TECHNICAL BULLETIN

[Issue No.] FA-A-0157

[Title] Compliance with IEC/EN61010-2-201(issued in 2013)

[Relevant Models] MELSEC-Q/L/QS/AnS/QnAS series, CC-Link, CC-Link/LT, and CC-Link IE Field Network

(a) Change of the insulation wall height of power supply module internal terminal block

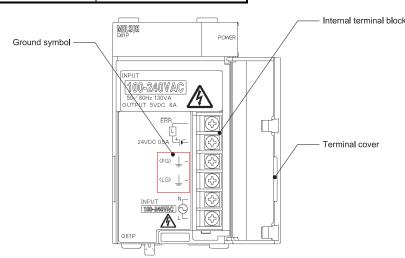
In order to keep the insulation distance between each internal terminal, the height of the insulation wall (side and back) has been changed.

However, the following modules are exempt because these modules already have internal terminal block that satisfies the required insulation distance.
